Technical product information

Topic	Bentayga V8 Kovomo - DTC P227900 evident within the engine control unit 0001
Market area	United States E05 Bentley USA and rest America (6E05)
Brand	Bentley
Transaction No.	2071575/3
Level	EH
Status	Approval
Release date

Figure 2

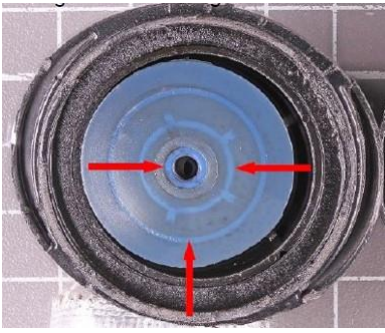
Hint: The diaphragm of 0P2 103 210G and 0P2 103 211H are blue (Figure 2)

Figure 4

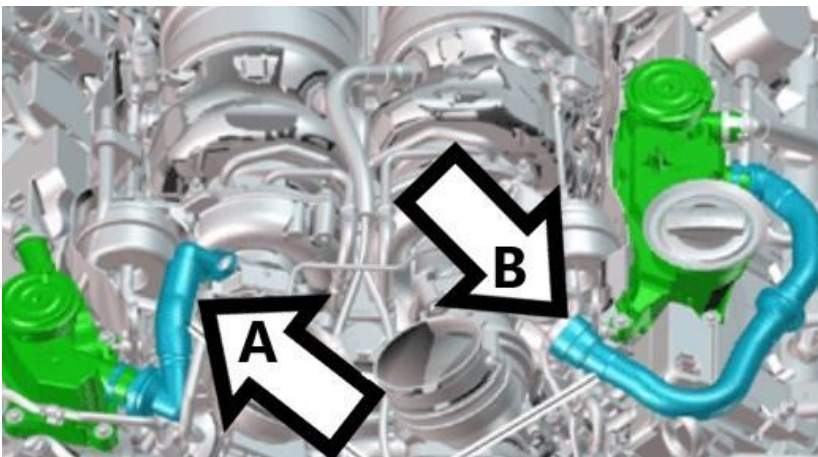
Referring to Figure 4

- Point A - Is the bank 1 (right) turbocharger full load pipe
- Point B - Is the bank 2 (left) turbocharger full load pipe

1) Referring to Rep.Gr 21 - Replace the bank 1 (right) and bank 2 (left) turbocharger full load pipes

Note: when conducting the instructions within this TPI please ensure the bank 1 and bank 2 turbocharger full load pipes are replaced in pairs (during the same workshop visit)

Figure 5

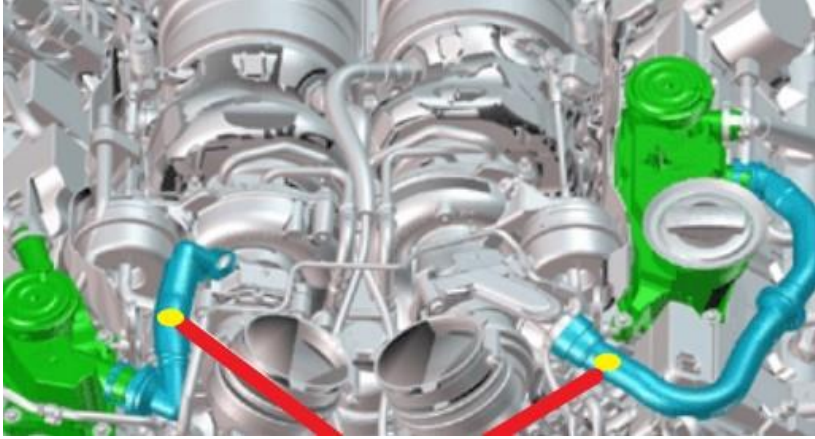
2) To confirm both pipes have been replaced using the H level parts the operative must place a yellow paint mark as shown in Figure 5
